DIVISION OF MINES AND GEOLOGY

August 12, 1980

Following is the Division of Mines and Geology Position Statement on Trail 5 "offset feature", San Onofre Beach State Park.

Figure 2a. Sketch of southeast wall of Trail 5 arroyo at "offset feature." "A" and "B" are location of attitudes mentioned in text. Scale approximately 1"=10'.

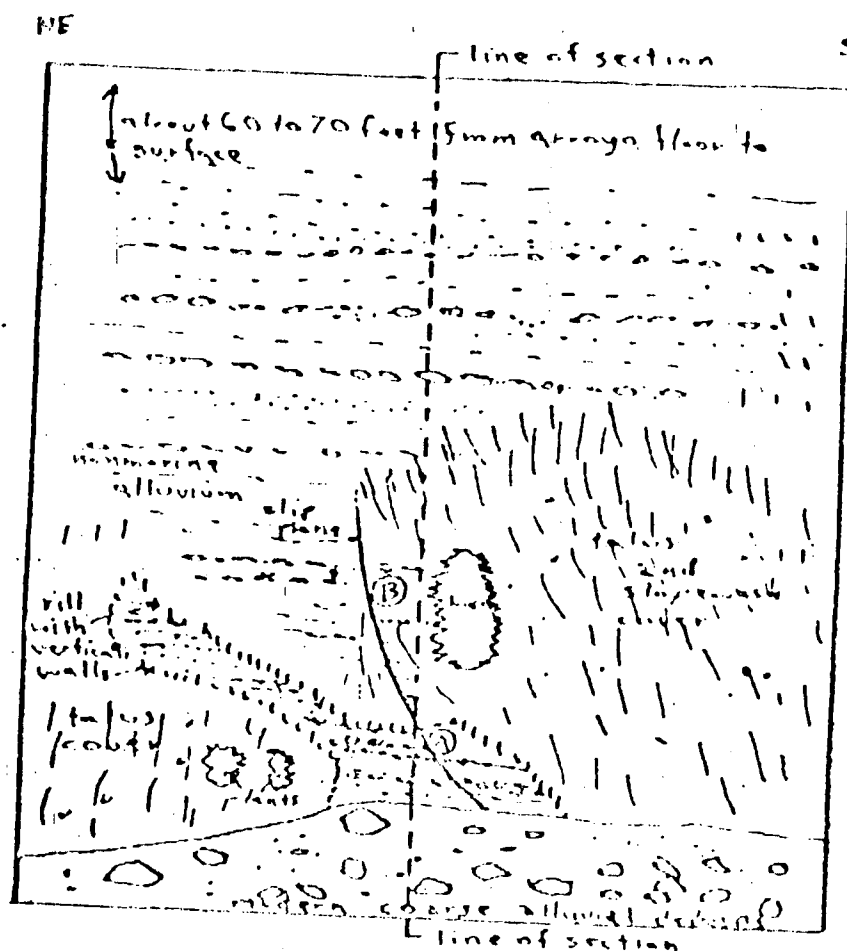
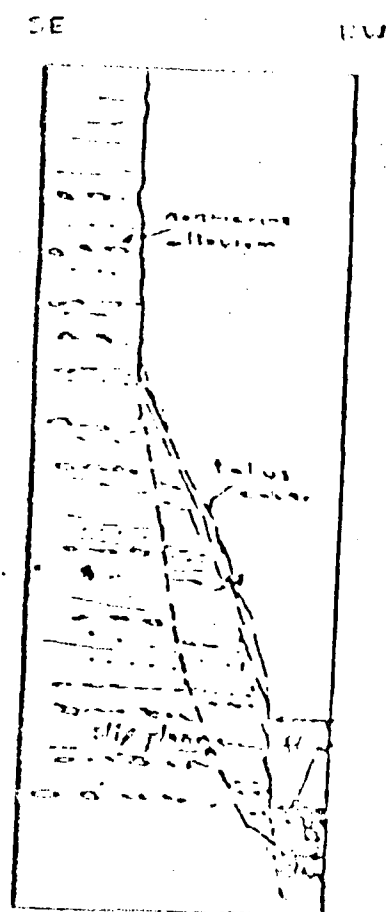
Near the base of the east wall of the arroyo and about 600 feet inland from the shoreline, where the walls of the arroyo are at least 60 feet high (estimated), a curvilinear surface intersects the stratified alluvium. This is the "offset feature" of Trail 5 (figure 2). A block of alluvium approximately 10 to 12 feet above the modern stream gravel on the arroyo floor has dropped down on the southeastern (seaward) side along a slip plane which can be followed for about 10 feet above the floor. In detail the plane is curving, slightly more moist (darker colored clay), locally contains rootlets in the upper part, and varies in attitude from N 10° W 32° SW about 3.5 feet above the floor of the arroyo (point A in figure 2) to N 30° W 60° SW about 8 feet above the

floor of the arroyo (point B in figure 2). The block of well-consolidated alluvium contains gravel beds that exhibit separation of about 16 inches (down on the southeast) compared with "in place" beds in the walls of the arroyo where they were traced across the slip plane. The surface of the block of alluvium is mostly covered with talus and slopewash debris so that individual beds of alluvium cannot be traced across the face of the block (figure 2).

Under certain lighting conditions, as viewed from the bottom, it appears as though a "crack" extends toward the surface beyond the actually dug out intersection of the slip plane with the wall of the arroyo (which makes a line). However, when viewed from the top of the northwestern bank of the arroyo directly opposite (with 8-power binoculars) in afternoon sun no such feature extends to the surface nor can offset layers be seen higher up in the section exposed in the walls of the arroyo.

In conclusion, it appears that the "offset feature" is the result of the intersection of a slip plane with the wall of the arroyo, and is not a fault feature of tectonic significance.

This intersection makes a line along which several layers can readily be seen to have been offset by the slumping of a block of the nonmarine alluvium. The slip plane behind this slump block probably "daylights" above the block (about 12 to 15 feet above the arroyo floor) although slopewash and talus obscures the relations at present. Slumps are common along the walls of this arroyo and large landslides are typical in the alluvium along the seacliffs nearby. Rapid runoff during storms must be very erosive to the base of the arroyo walls in the narrow confines of this gorge. Accordingly, high volume intermittent streams can create undercut banks which can slump under the force of gravity. Because of the coarse modern debris that chokes the floor of the Trail 5 arroyo the base of the slump bound by the slip plane described above cannot be seen. The shallower dip near the bottom of the exposure (point A in figure 2), however, permits the inference that the feature does not extend to any great depth beneath the present exposure. At the elevation of the present arroyo floor it is probably 20 to 25 feet down to the terrace (wave-cut) platform.
